FIRE SERVICES DEPARTMENT LICENSING AND CERTIFICATION COMMAND

FSD Circular Letter No. 8/2021

Additional Requirements for the Pressurization of Staircases

Figure I – Sample of Notice Plate

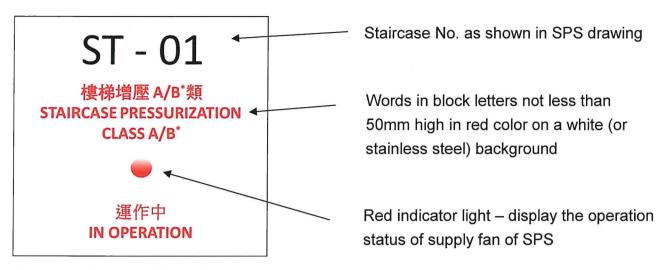
- a) The notice plates shall be bilingual bearing the words 'Staircase Pressurization Class A/B*' and '樓梯增壓 A/B 類*' with letter height not less than 50 mm as shown in Figure I at Annex. The characters shall be painted in red on a white or stainless steel background.
 - * Specify Class A or B according to the type of SPS installed.
- b) The notice plates shall bear a red indicator light (as shown in Figure I at Annex) which shall be on while the supply fan of the SPS protecting the staircase is in operation.

Figure II – Locations of Notice Plate

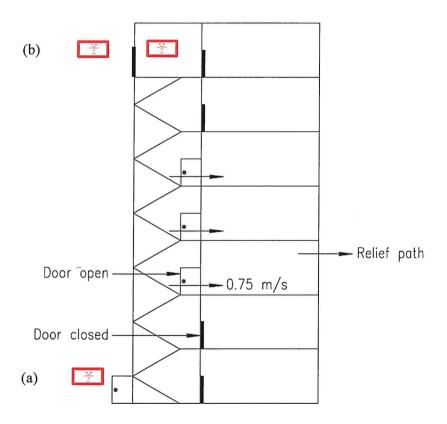
- d) The notice plates shall be provided at every staircase protected by SPS and shall be firmly affixed at a conspicuous position at the following locations as illustrated in Figure II at Annex:
 - i) Outside the final exit; and
 - ii) Both inside and outside the exit on the top floor.
- e) For buildings installed with SPS(s) and with provision of refuge floor(s), notice plates shall also be firmly affixed at a conspicuous position both inside and outside the exit/entrance of the staircase(s) on the refuge floor(s).
